RE: THAKEHAM TILES LTD, ROCK ROAD, PULBOROUGH – RESPONSE TO LOCAL HIGHWAY AUTHORITY TRANSPORT COMMENTS

I am writing further to initial observations dated 29th January 2026 in respect of planning application DC/25/2087, which seeks outline planning permission for residential development comprising up to 108 dwellings (including a mix of private and affordable housing units), with associated infrastructure including vehicular, cycle and pedestrian access, parking, landscaping, open space and play provision, and sustainable drainage with all matters reserved except access.

**STAGE 1
ROAD SAFETY AUDIT REPORT**

Figure 1 - Updated Site Access Plan

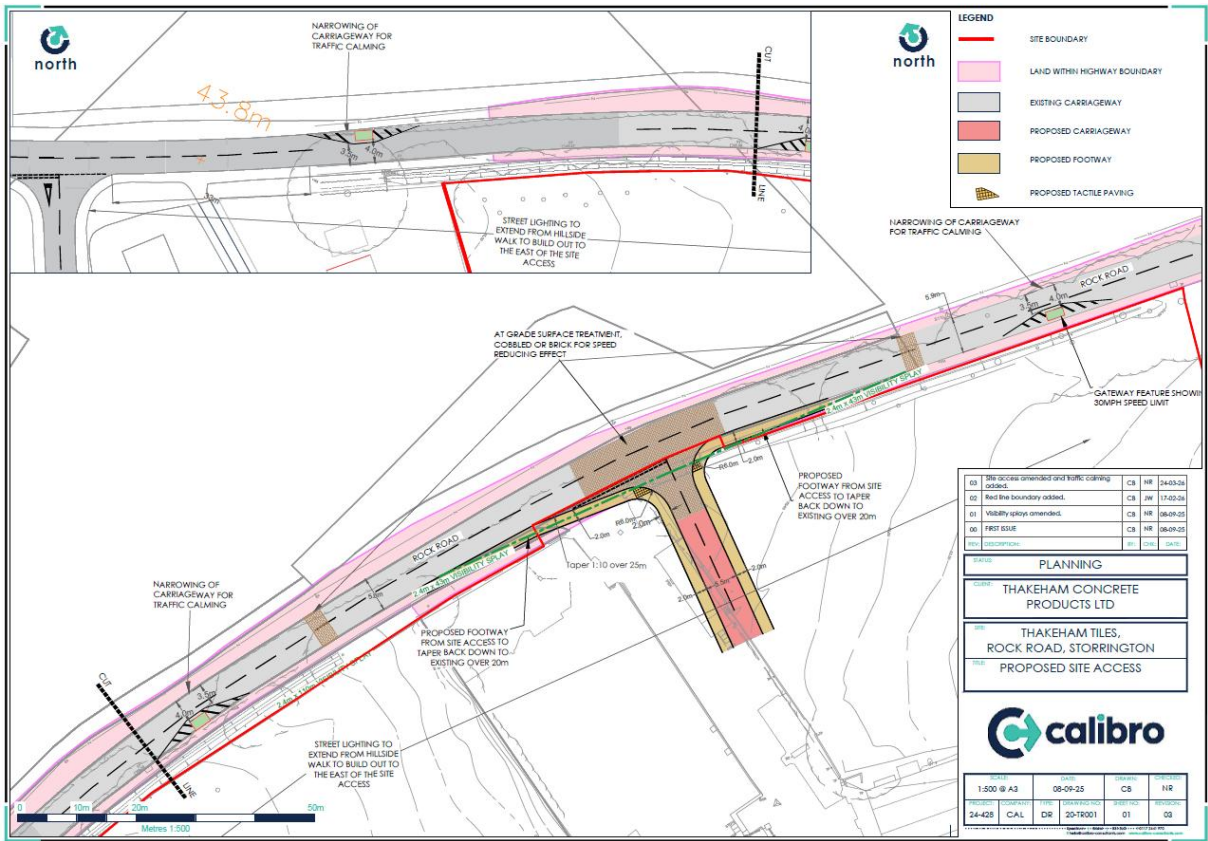
The existing access is not considered suitable to serve the development due to the substandard visibility splays.

Speed surveys have been undertaken and identify that the 85th % speeds are 43.1mph westbound and 42.6mph eastbound. The applicant has then made a wet weather adjustment to further reduce the speeds. This approach is incorrect and CA 185 identifies all speed measurements should be taken in dry weather conditions, and if wet weather conditions are observed amendments are made to increase the recorded speeds. As such the speeds to be utilised for the visibility splays should be as above. (it is noted that the

The applicant has provided a hybrid approach to visibility based on DMRB reaction times and MfS deceleration rates. The approach is not accepted and given the need to utilise the higher speeds and DMRB visibility requirements it does not appear that the proposed access could provide suitable visibility splays in its current form.

It is advised that the applicant either revisits the visibility requirements of the access or develops proposals that would support a reduction in vehicle speeds and thus visibility requirements similar to those that were secured under the previous permission. If the later then it is advised that the applicant contact WSCC directly to discuss any additional consultation requirements.

Following the comments made by the LHA and discussions with the Local Planning Authority it has been decided to revert back to a junction design similar to the access approved under the previous submission.

As such, the amended proposal reflects the previously approved junction design and incorporates the extension of the existing 30mph zone, which is currently located some 160-metres west of the existing access, to a point some 100-metres to the east of the proposed access. In order to encourage vehicles to reduce their speeds on Rock Road and ensure appropriate visibility splays are achievable, the access junction will be built out 1-metre from the southern footway on Rock Road resulting in a reduction of the effective width of the carriageway which will have a calming effect on vehicle speeds on Rock Road in line with MfS principles. The build out will increase visibility splays from the junction onto Rock Road and nullify the effect of the bend in the carriageway.

As illustrated by the figure above, the proposed access has been designed such that visibility is achievable over a minimum of 43-metres in either direction from a 2.4-metre set-back position, albeit that the location of the junction affords visibility of a distance greater than this in reality.

The proposed access incorporates a minor road approach width of 5.5-metres and radii of 6.0-metres. In order to achieve the necessary visibility splay (discussed in the paragraphs below) the junction has been stepped forward with a modest local realignment of Rock Road. Contiguous footways of two-metres width are proposed to be provided on both side of the access road which will connect to the existing footways on the southern side of Rock Road.

The traffic calming scheme will comprise two 3-metre strips of at-grade surface treatment located either side of the proposed access, which itself shall receive a similar surface treatment comprising cobbles or brick. The surface treatment will provide a modest urbanising effect and to reduce vehicle speeds, following the principles of Manual for Streets (MfS). The proposed traffic calming is illustrated on Figure 1 above.

Allied with the above, it is proposed to provide a gateway feature located some 100-metres to the east of the proposed junction. This would comprise a kerbed build-out on the southern side of the carriageway which will narrow the effective width of Rock Road from 5.5-metres to 3.5-metres as shown on Figure 1 above. It is proposed that a planter will be positioned on the build out with a sign signalling the beginning of the 30mph speed limit. A photograph illustrating a similar scheme which is operational in the village of Bridge, Kent is included below for context.

Figure 2 - Swept Path Analysis of Fire Tender & Refuse Vehicle at Site Access

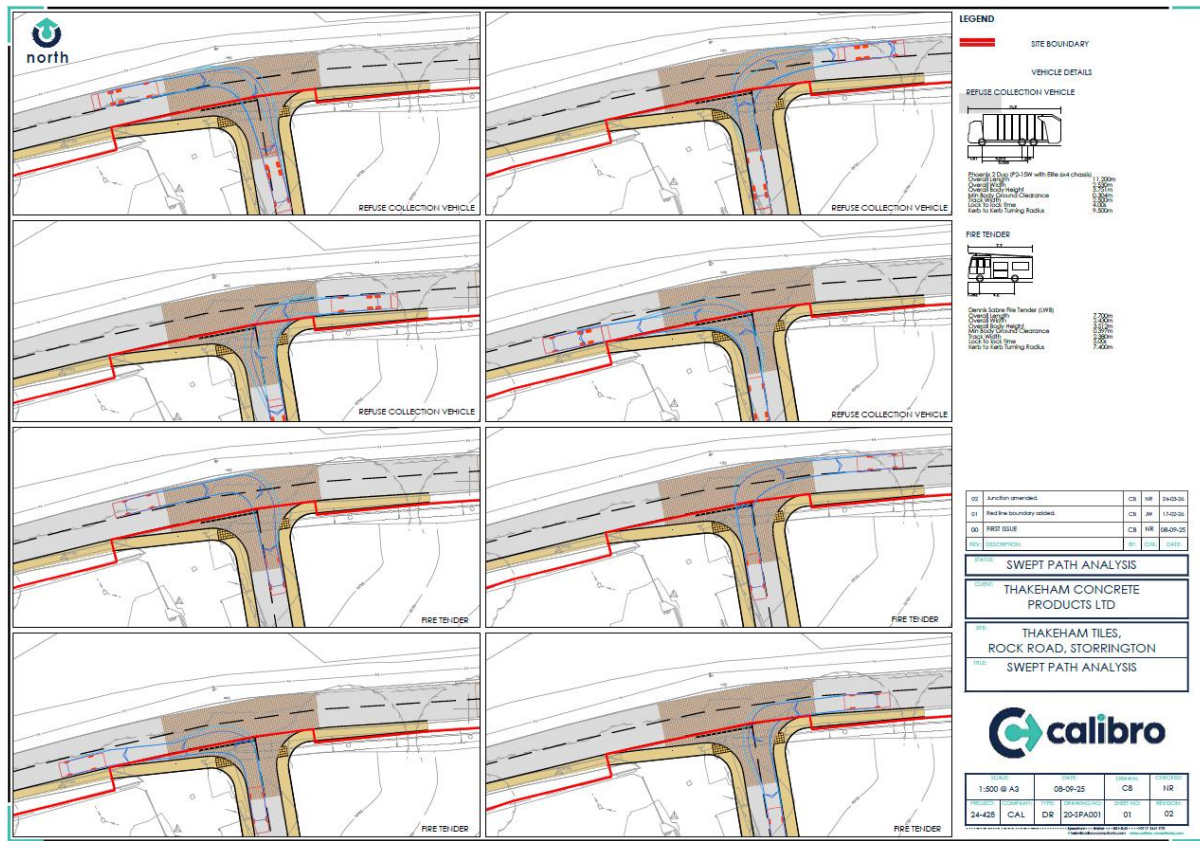
The vehicle swept path plots for a large vehicle negotiating the development access indicates that it will need to overrun the opposing carriageway to complete the turning manoeuvre, albeit that these movements will be infrequent. However, insufficient carriageway space may increase the risk of collision between vehicles entering and exiting the development access simultaneously or may encourage large vehicles to overrun the footway putting pedestrians waiting on the footway of being struck turning vehicles.

Ensure that sufficient width is provided for two-way traffic movements, alternatively ensure that there is sufficient inter-visibility between approaching drivers to prevent drivers entering the access when opposed by other vehicles.

The swept-path analyses above demonstrates that a refuse vehicle can safely negotiate the proposed site access junction and that a car can wait at the give-way line whilst the refuse vehicle executes its manoeuvre.

The above plan includes the area of highway maintainable at public expense, and it can be confirmed from this, that the proposed works can be achieved within either the extent of public highway or land within the demise of the application site.

The design team agrees with this recommendation and will take it forward to detailed design.

Adequate forward visibility will be provided, based on Stopping Sight Distance (SSD) derived from recorded 85th percentile vehicle speeds, in accordance with Manual for Streets.

TITLE: SWEPT PATH ANALYSIS

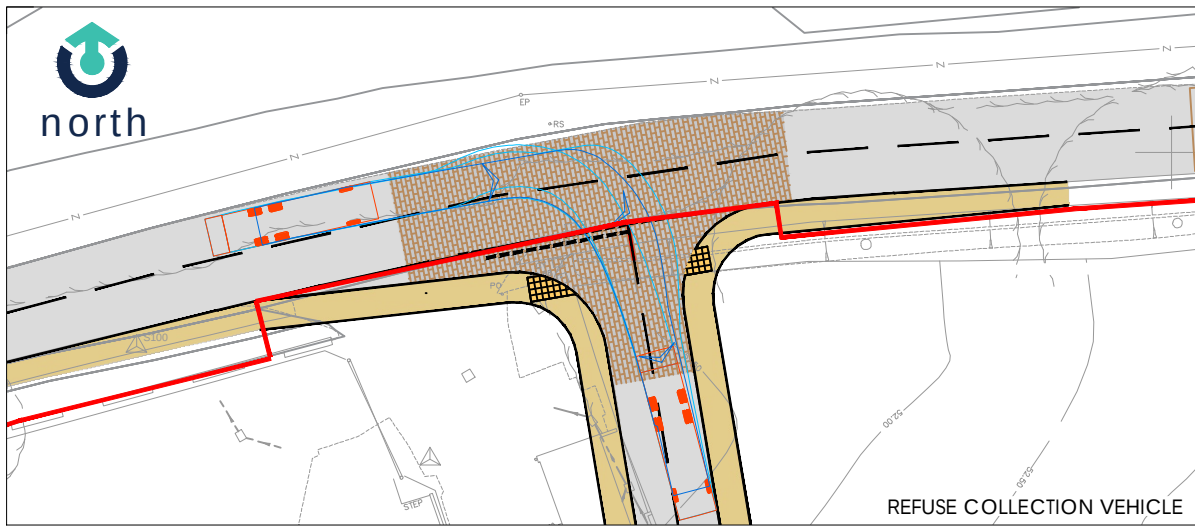
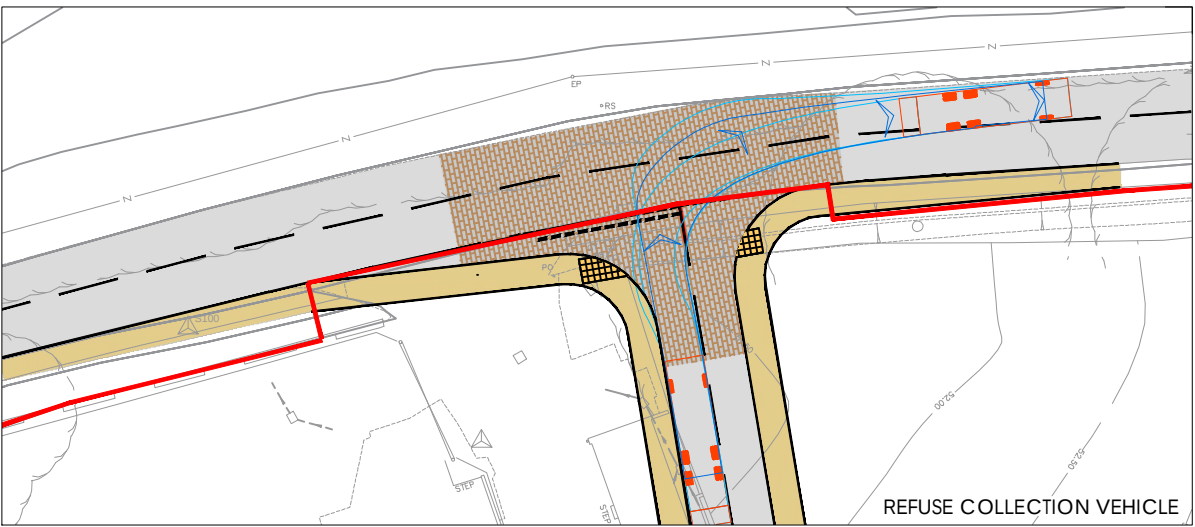
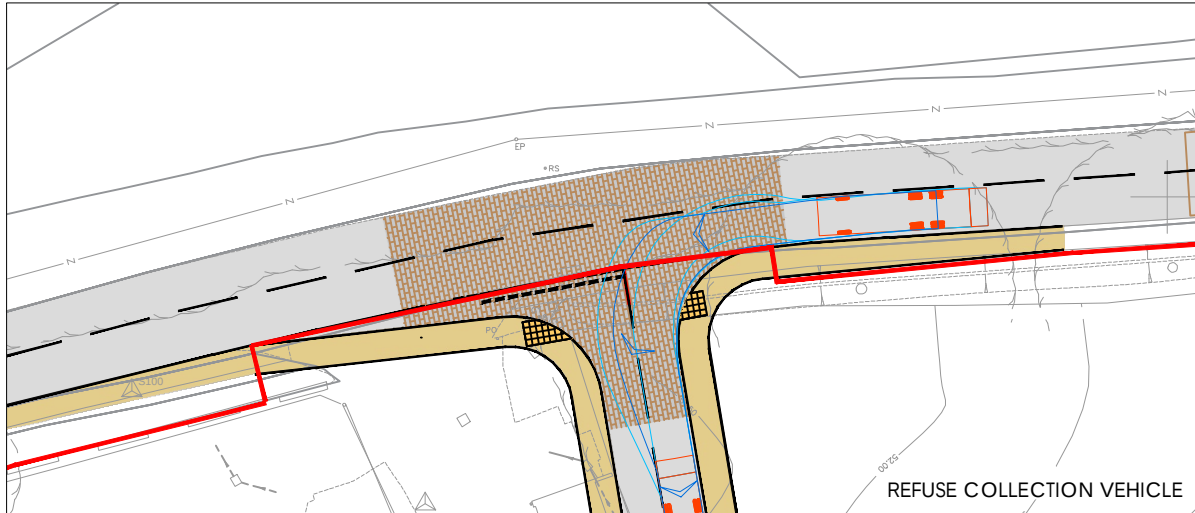
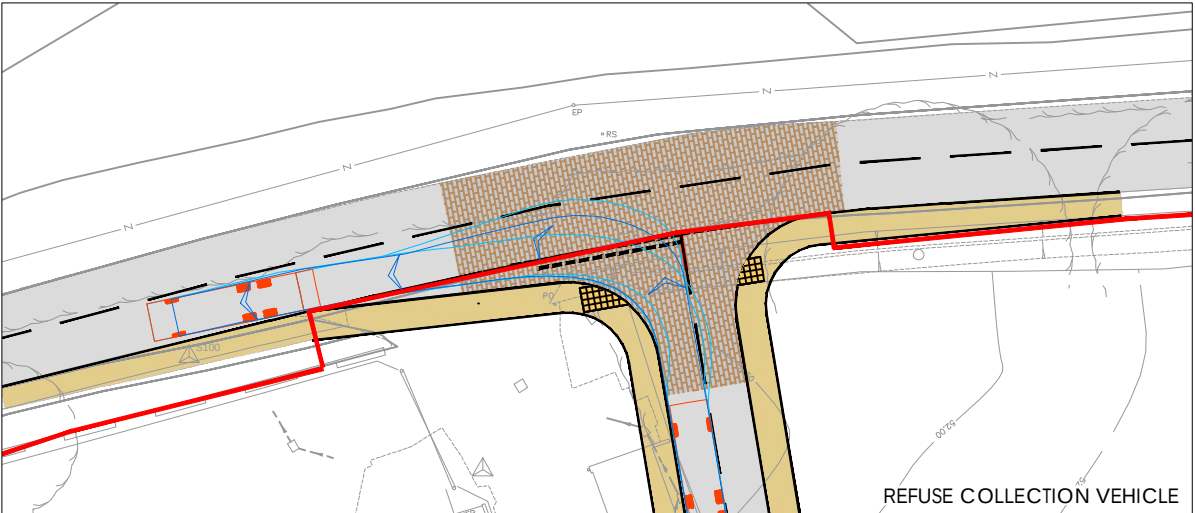
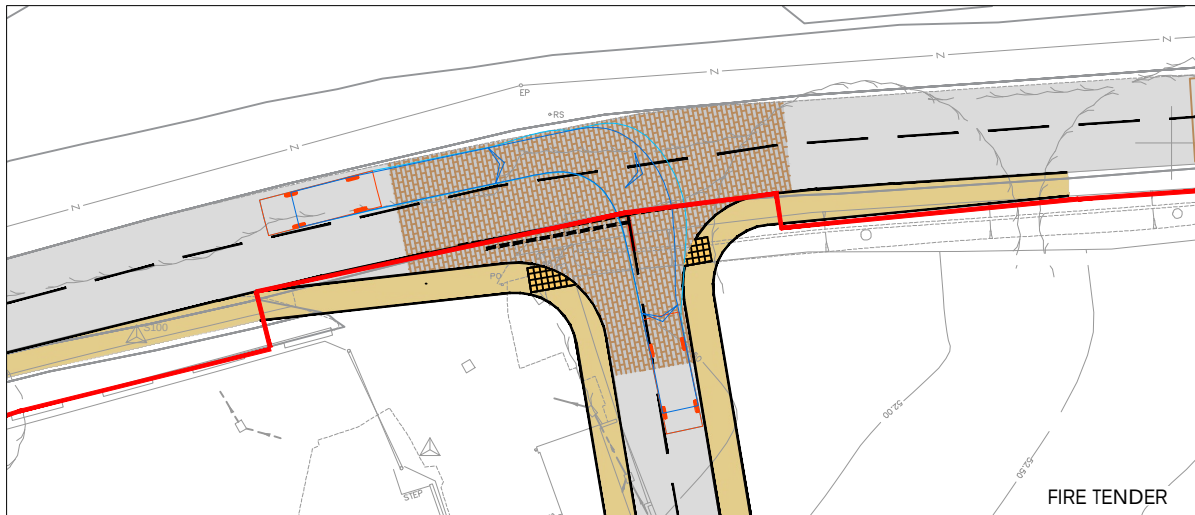
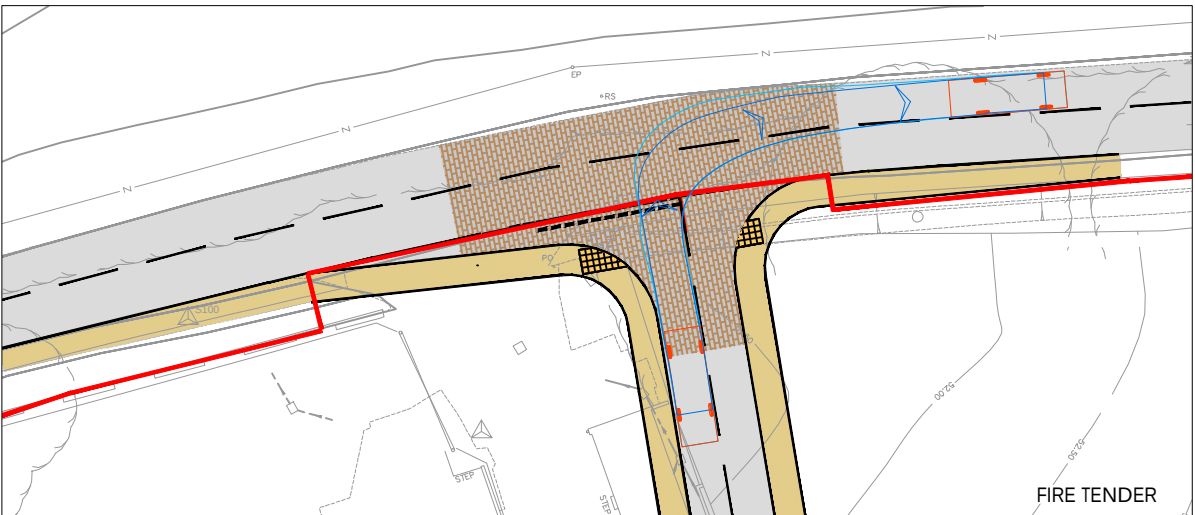
The vehicle swept path plots for a large vehicle negotiating the development access indicates that it will need to overrun the opposing carriageway to complete the turning manoeuvre, albeit that these movements will be infrequent. However, insufficient carriageway space may increase the risk of collision between vehicles entering and exiting the development access simultaneously or may encourage large vehicles to overrun the footway putting pedestrians waiting on the footway of being struck turning vehicles.

Ensure that sufficient width is provided for two-way traffic movements, alternatively ensure that there is sufficient inter-visibility between approaching drivers to prevent drivers entering the access when opposed by other vehicles.

The design will demonstrate that the required visibility can be achieved on site, with due consideration of alignment and potential obstructions. Where appropriate, reference will be made to Design Manual for Roads and Bridges.
